UNCLE RALPH LETTER

Meeting Summary

In addition to discussing the NRC review of the QAPD, DOE presented changes that were being made to the "Nevada Nuclear Waste Storage Investigation Quality Assurance Plan," (NNWSI/88-9). These changes were of two types. One set of changes was being made to address the open items in the NRC safety evaluation of NNWSI/88-9. The second set was just additional changes being made by DOE. All of the proposed changes to NNWSI/88-9 are contained in Attachment 3. The staff stated at the beginning of the meeting that although it was prepared to listen to the additional changes proposed by DOE, it did not intend to provide any feedback on the acceptability of the changes during the meeting. DOE stated that it understood and that it did not expect acceptance during the meeting. When DOE had completed its presentation, the NRC staff noted that before NRC could perform a review of the additional changes to NNWSI, 88-9, DOE would have to formally request an NRC review and in that request identify the priority of the NNWSI/88-9 review with respect to other ongoing NRC reviews. DOE agreed to provide a letter. Attachment 4 is a draft copy of the revised NNWSI/88-

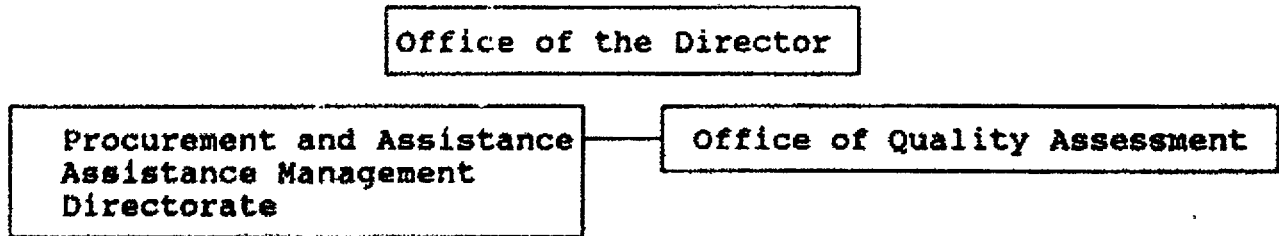
Delete "execution,"

Delete "training,"
